STATE OF MARYLAND
CRITICAL AREA COMMISSION
CHESAPEAKE AND ATLANTIC COASTAL BAYS
1804 West Street, Suite 100, Annapolis, Maryland 21401
(410) 260-3460 Fax: (410) 974-5338
www.dnr.state.md.us/criticalarea/

Re: Case No. 2005-0008-V William Trevillian (Lot 2)
Case No. 2005-0005-V Gary Lenz (Lot 1)

HERONS WATCH "PASADENA" PARCEL 127, LOTS 1 & 2 TAX MAP 25, GRID 22 3RD DISTRICT ANNE ARUNDEL CO. MD

PROPOSED SITE PLAN SCALE: 1" = 40' DATUM: 0.0 MLW

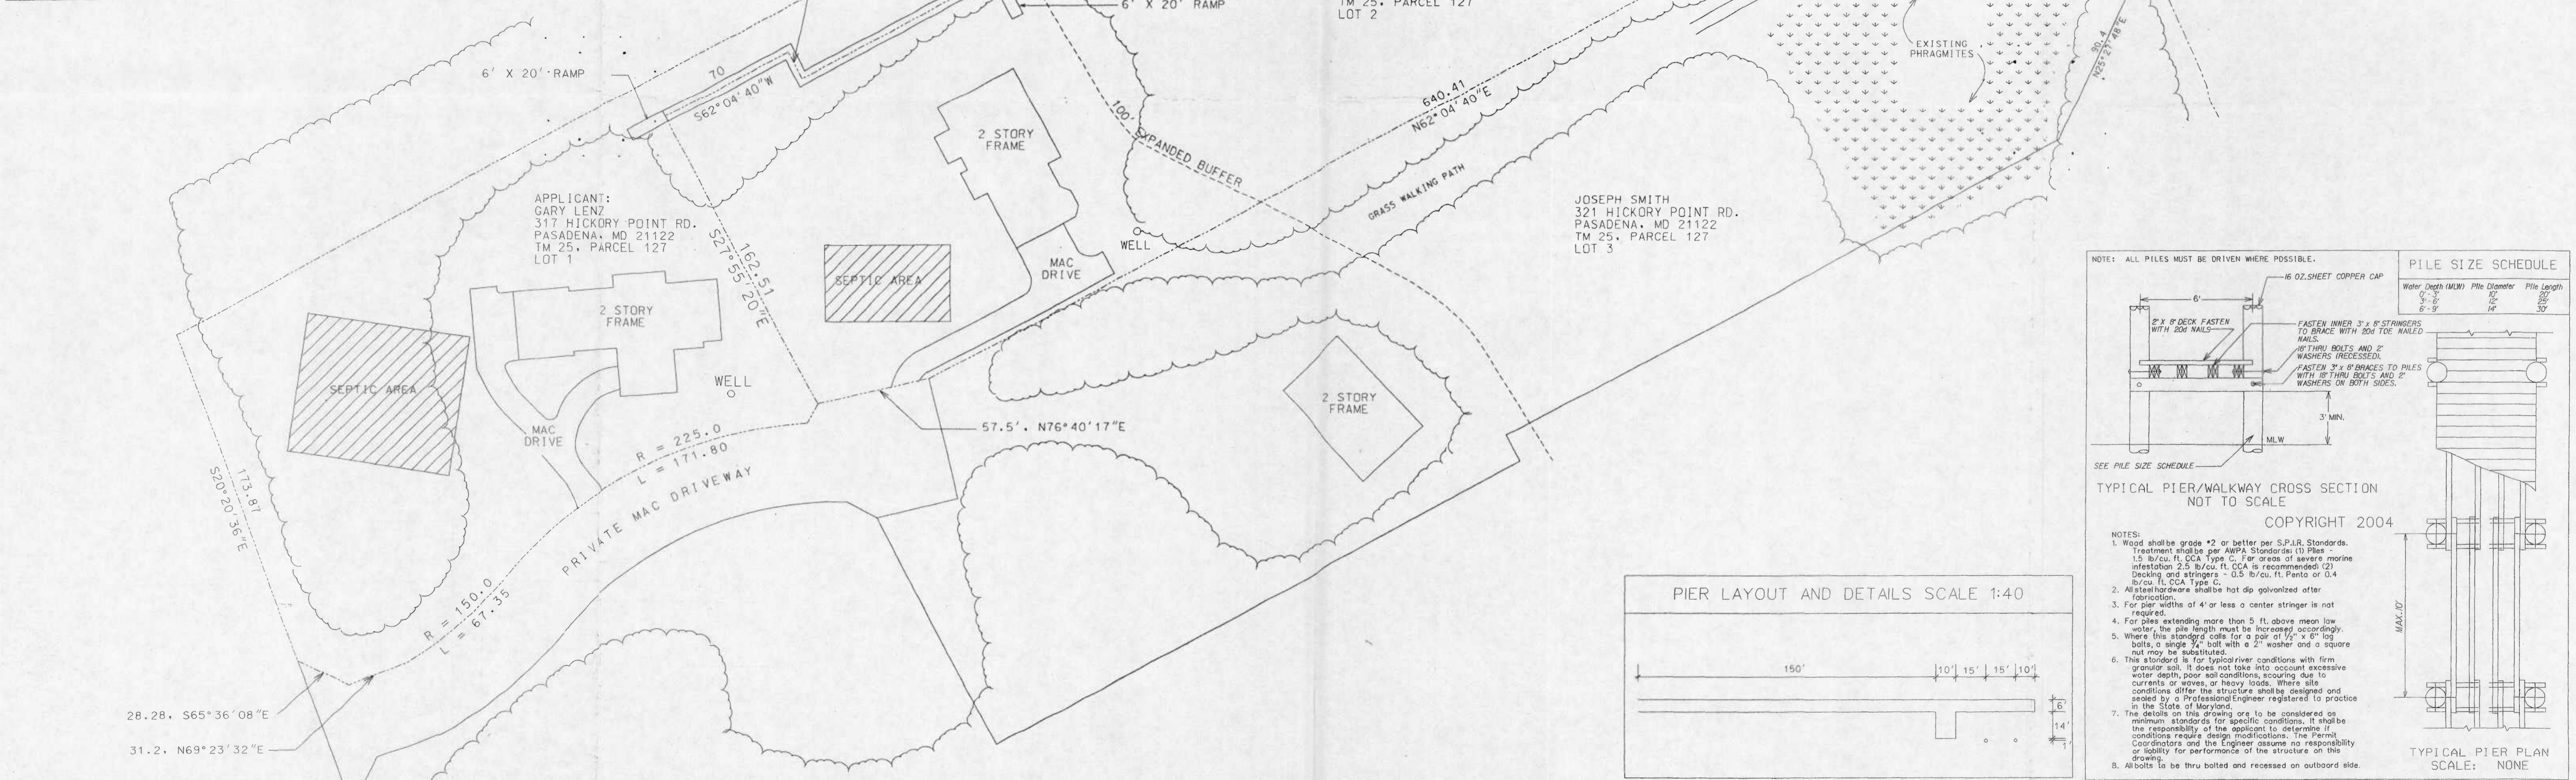
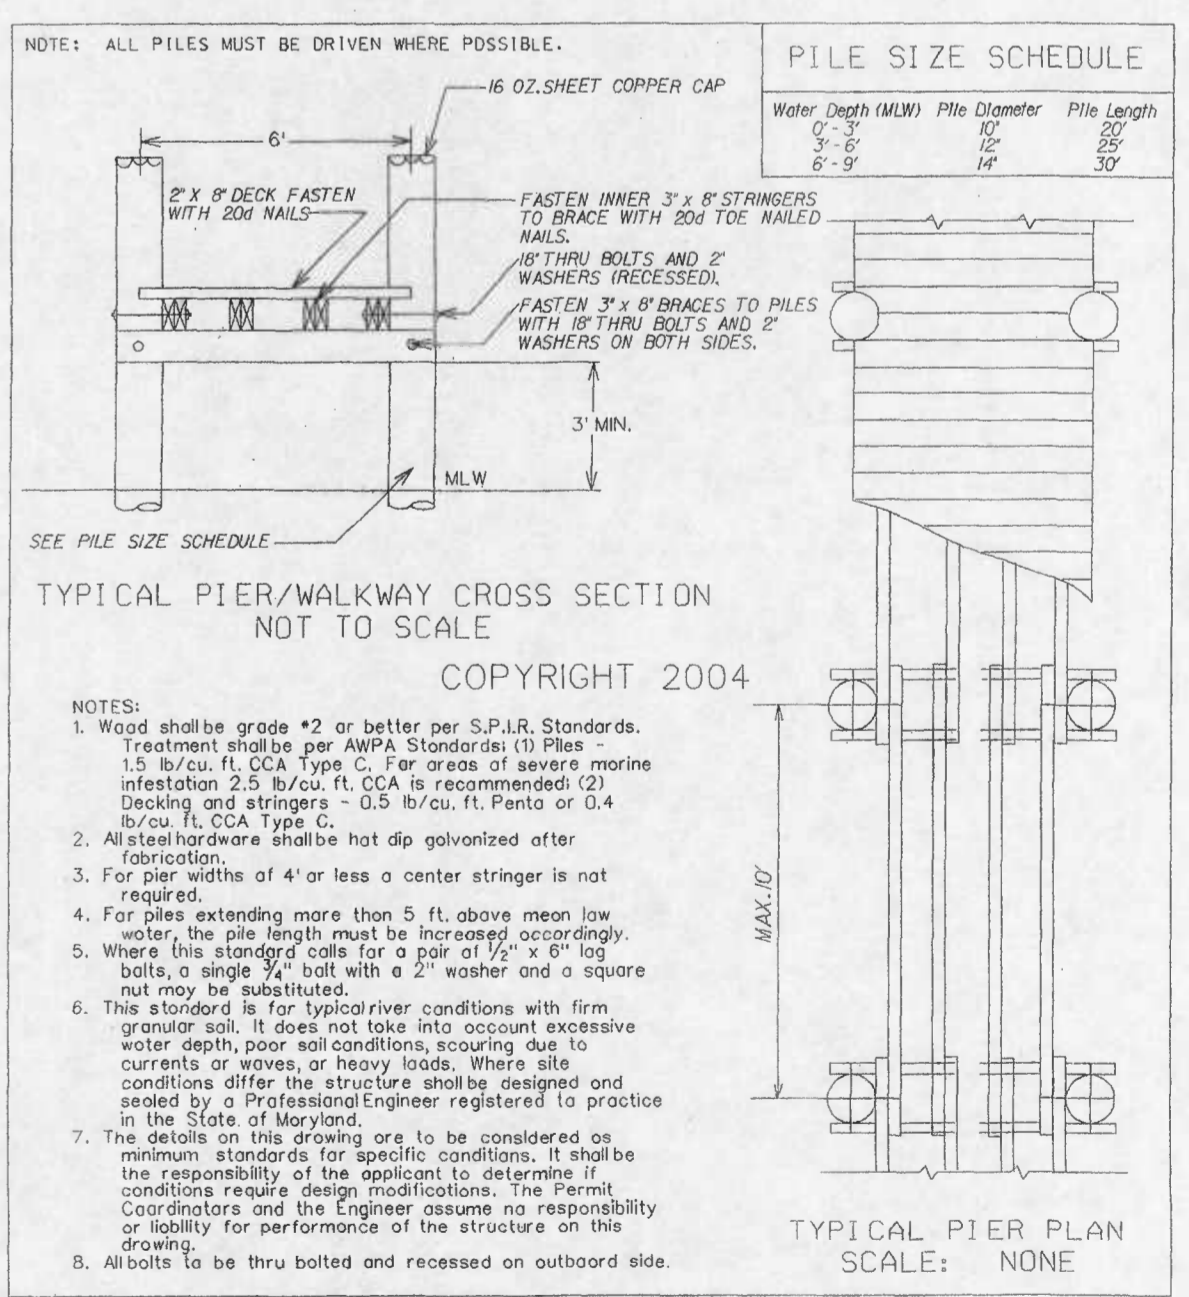
recording of the 1989 subdivision plat. The 100-foot Buffer (as measured from the edge of tidal wetlands) is shown incorrectly on the revised site plan. Based on the Critical Area maps for Anne Arundel County, it appears that the LDA and RCA lands on Lot 1 and Lot 2 are shown incorrectly on the revised site plan. The applicants should provide a revised site plan showing accurately the 100-foot Buffer and the LDA and RCA lands on Lot 1 and lot 2.

- 2) As shown on the revised site plan, the applicants propose the following development activities within the Critical Area: a 6 foot by 20 foot ramp on Lot 2; a 6 foot by 85 foot section of raised walkway and a 6 foot by 20 foot ramp along the property boundary of Lot 1 and Lot 2; and a 6 foot by 135 foot wood chip path (a raised walkway was proposed on the original site plan) and a 6 foot by 20 foot ramp on Lot 1. As observed during my site visit, the area of the proposed access path and walkway is relatively flat and forested (refer to the attached photographs), with the exception of the ramp on Lot 2, which is proposed in an area of mowed grass. Based on conversations with the Department of the Environment, Mr. Trevillian and Mr. Lenz have applied for a permit to construct a joint-use walkway over tidal wetlands. The walkway will connect at the shoreline to the piers proposed for each lot.

- 3) As stated in the Critical Area report, 4,000 square feet of disturbance is proposed to construct a 775 foot raised walkway. As shown on the site plan, the proposed raised walkway extends within the 100-foot Buffer on Lot 1 and Lot 2 and through tidal wetlands to the mean high water line. The applicants should provide a revised site plan showing the length of the walkway located within the Buffer and calculations of the area of disturbance proposed within the Buffer as part of the current variance request.
